SEWAGE DISPOSAL SYSTEM

DEPARTMENT OF HEALTH AND MENTAL HYGIENE

P 511063

SUBDIVISION _____ LOT _____ ROAD 8685 Baltimore Washington Boulevard

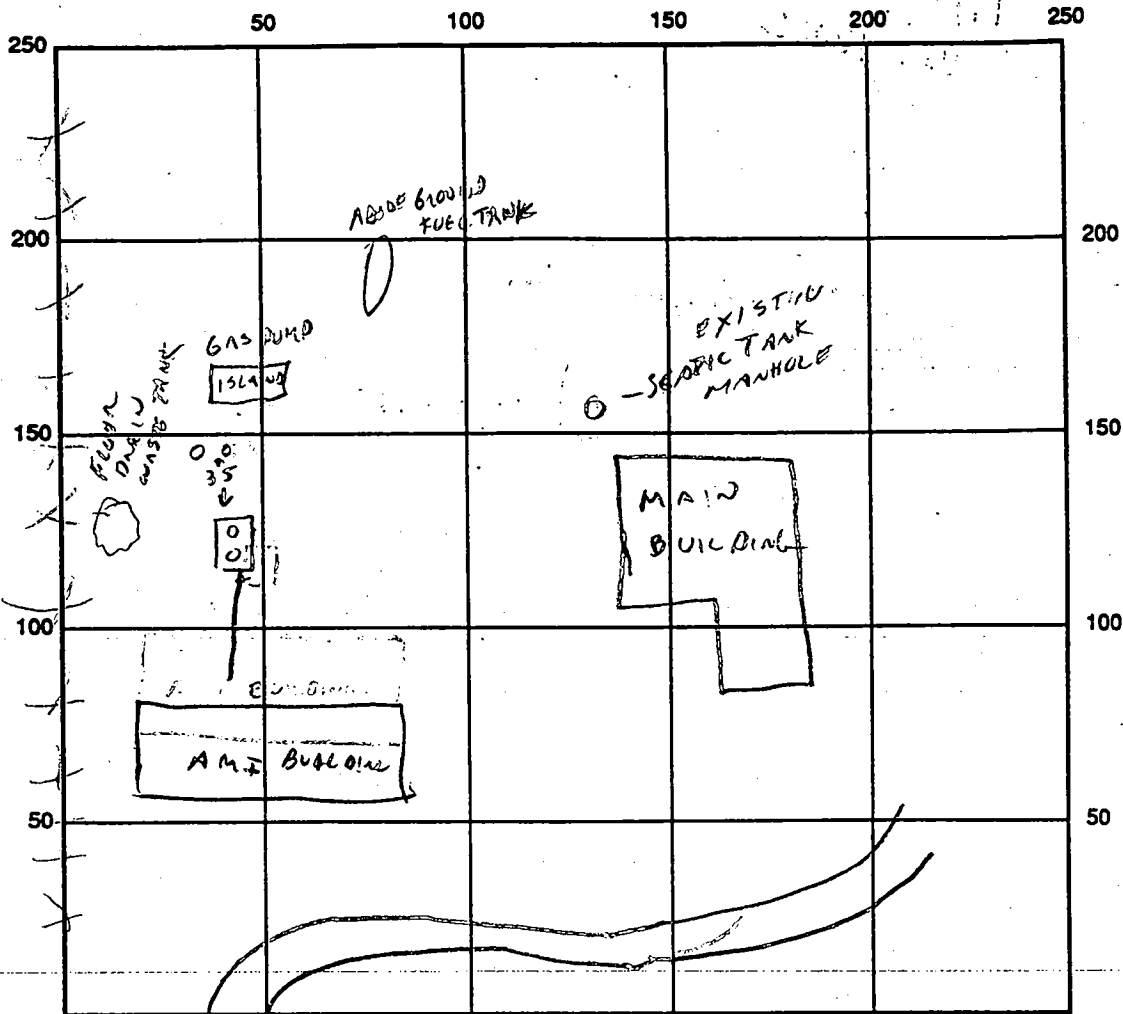
REMARKS: NEW PLUMBING CONNECTED TO WHAT WAS REPORTED TO BE SEPTIC SYSTEM,
BUT TURNED OUT TO BE FLOOR DRAIN WASTE TANK FOR AUTOMOTIVE FLUIDS,
SITE HAS 4" THICK ASPHALT; FUEL TANKS AND OTHER TANKS
DISTRIBUTED ALL ACROSS SITE AS WELL AS UTILITY LINES
IN UNKNOWN LOCATIONS,

TANK ALL ALL SAND - APPEARANCE, LANDSCAPE POSITION, HISTORY
OF SITE & GENERAL VICINITY SUGGEST THIS IS PROBABLE FILL MATERIAL,

CONCLUSION: NO REASONABLE LOCATION TO INSTALL DRAINFIELD;
SEPTIC HOLDING TANK TO BE UTILIZED UNTIL PUBLIC SEWER IS PRACTICAL,

INSTALL 1000 GALLON TOP SEAMED SEPTIC TANK FOR INTERIM SERVICE AS A HOLDING TANK UNTIL A DETERMINATION CAN BE REACHED AS TO A PERMANENT METHOD OF DISPOSAL.

Call for inspection when tank is in place so that a sanitarian can approve the size and location.
